## OAP7144

### Opel & Vauxhall 1.4 Petrol

Fig. 1

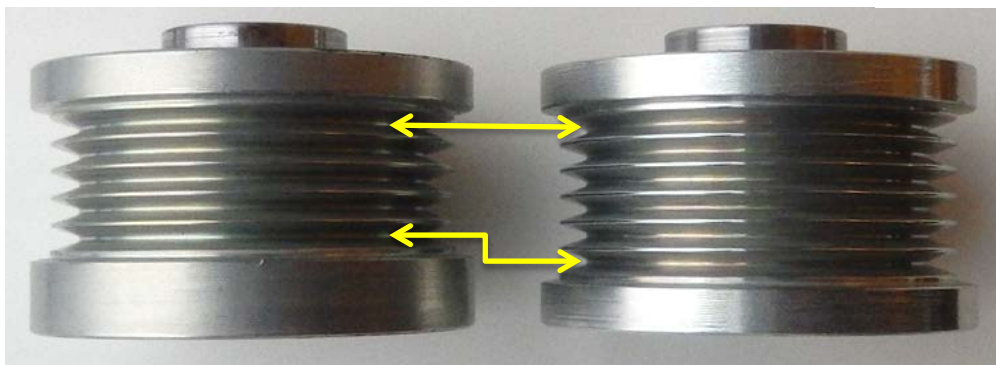
On certain Opel/Vauxhall engines (codes: A14NEL, A14NET, A14XEL, A14XER) the belts may have 5 or 6 ribs while the pulleys may have 5 or 6 grooves. It depends on the manufacturing date of the car. Gates recommends replacement of a 5 groove OAP (Fig.1 left side) with the 6-grooved OAP7144 (Fig. 1 right side).

If a belt with 5 ribs must be installed on to OAP7144 (Fig. 2), the outer groove (away from the engine) must be left open. If the belt is not placed correctly on the OAP like this, severe misalignment occurs, which may cause premature failure.
